Proposal #05: 3665-00-70, WISC 2026126
Town Burke, Daentl Road
Token Creek Bridge B-13-0912
LOC STR
Dane County

This is Addendum No. 01, which provides for the following:

ADDENDUM NO. 01

Addendum No. 01
ID 3665-00-70
Revised Sheet 99
January 7, 2026

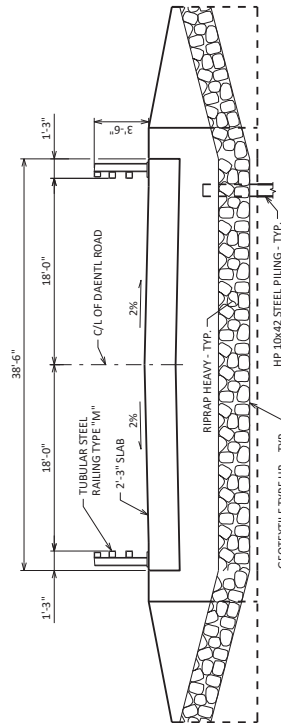
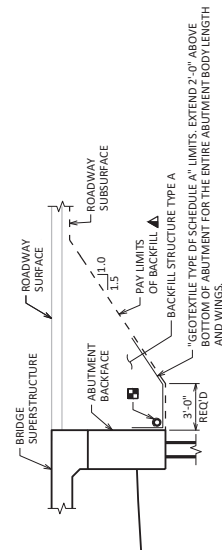
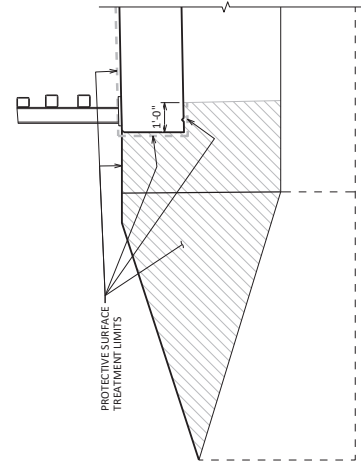
Revised Plan Sheets	
Plan Sheet	Plan Sheet Title (brief description of changes to sheet)
99	Structure Plan Sheet 2 – Total Estimated Quantities Table (rounded railing quantity)

513.4061	RAILING TUBULAR TYPE M	LF	(110)	---	---	(110)
516.0500	RUBBERIZED MEMBRANE WATERPROOFING	SY	---	8	8	16
526.0101	TEMPORARY STRUCTURE (10+00)	EACH	---	---	---	1
